2025 updates:-

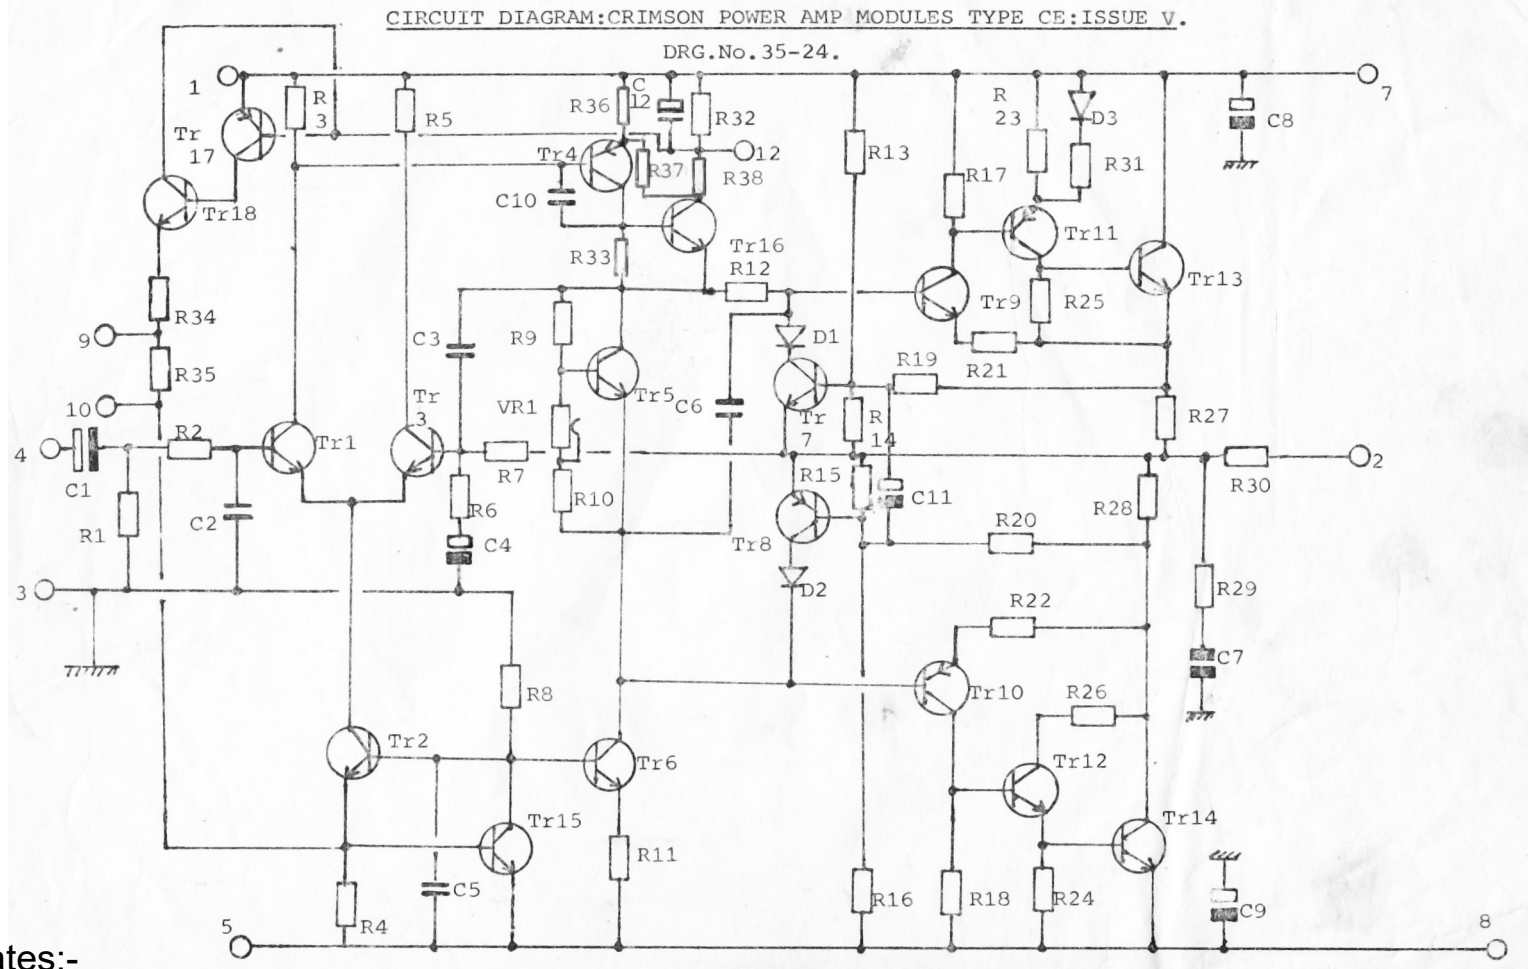
- 1 R32 to BAT83 series 56k
- 2 R37 to 180R
- 3 C12 to 15uF(opt)
- 4 R30 to 4uH parallel 2R2 1W
- 5 R7 fit 10pF para.1206 under
- 6 Tr1,3 to ZTX696B
- 7 R9 to 12k & R10 to 10k
- 8 Tr5 to high Hfe note collector orientation and glue to driver

Renew all electrolytics C4 100uF
Set Iq pos rail (+/-45v rails) to 17mA 2
minutes. C11 best removed.
